SERVICE BULLETIN

EC21-023

DTC P0300 AND/OR P0301(2/3/4/5/6) IS STORED DURING A COLD START

APPLIED VEHICLES: 2022 Frontier (D41)

Figure 1

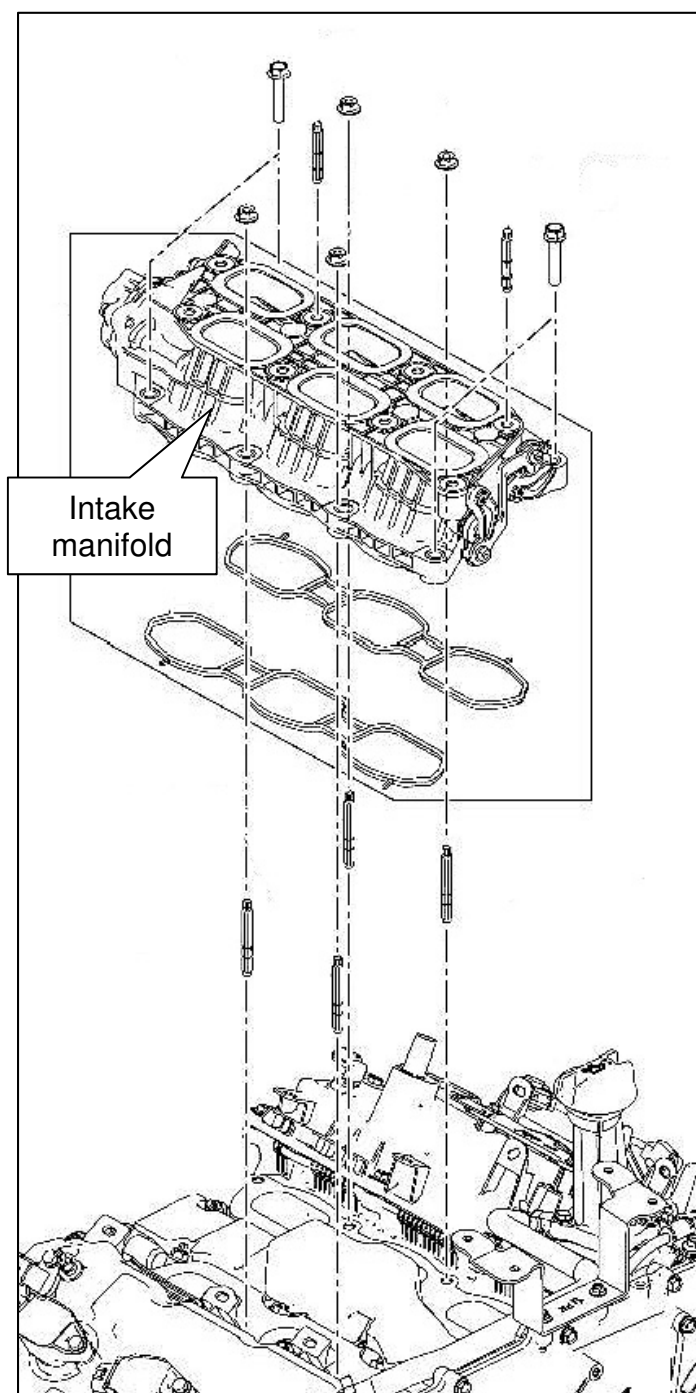
4. Replace the intake manifold (Figure 1) with one listed in the **PARTS INFORMATION** on page 4.
- Refer to the ESM: **ENGINE > ENGINE MECHANICAL > VQ38DD > REMOVAL AND INSTALLATION > INTAKE MANIFOLD**

DESCRIPTION	PART NUMBER	QUANTITY
Intake Manifold	14001-9BT0B	1
Gaskets	14035-9BT0A	2 (1)
Gaskets	14032-9BT0A	2 (1)
